[Docket No. FAA-2013-0023; Directorate Identifier 96-CE-072-AD; Amendment 39-17688; AD 99-01-05 R1]

Airworthiness Directives; Various Aircraft Equipped with Wing Lift Struts

ACTION: Final rule.

Figure 1

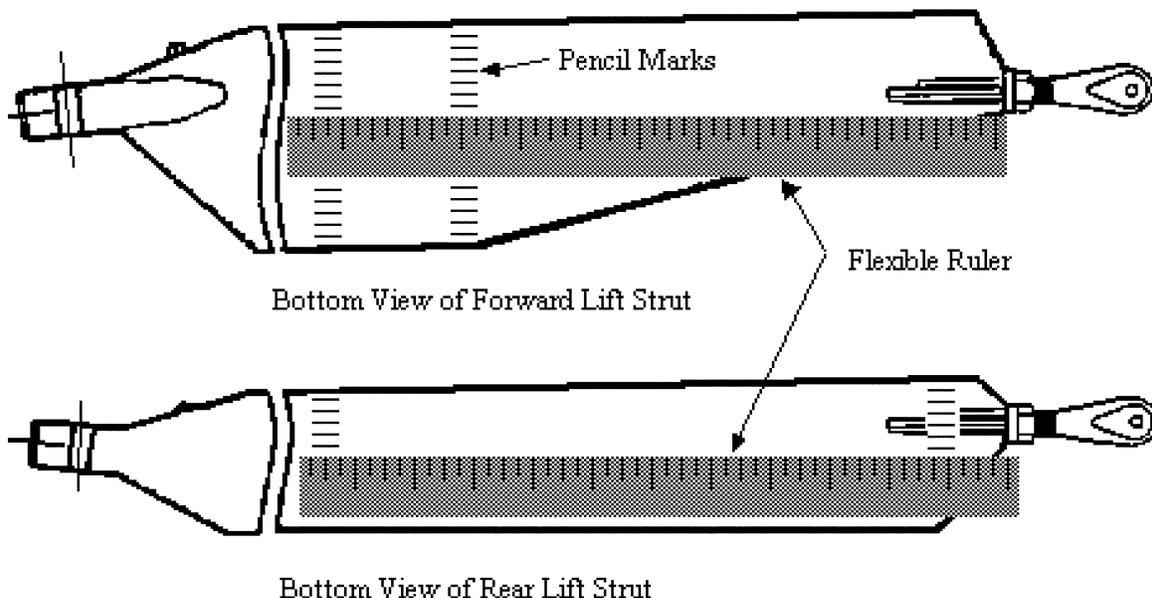
2. Using a flexible ruler, draw a 1/4-inch grid on the surface of the first 11 inches from the lower end of the strut as shown in Piper MSB No. 528D, dated October 19, 1990, or Piper MSB No. 910A, dated October 10, 1989, as applicable. This can be done using a soft (#2) pencil and should be done on both faces of the strut. As an alternative to drawing a complete grid, make two rows of marks spaced every 1/4-inch across the width of the strut. One row of marks should be about 11 inches from the lower end of the strut, and the second row should be several inches away where the strut starts to narrow. Lay the flexible ruler between respective tick marks of the two rows and use tape or a rubber band to keep the ruler in place. See Figure 1.
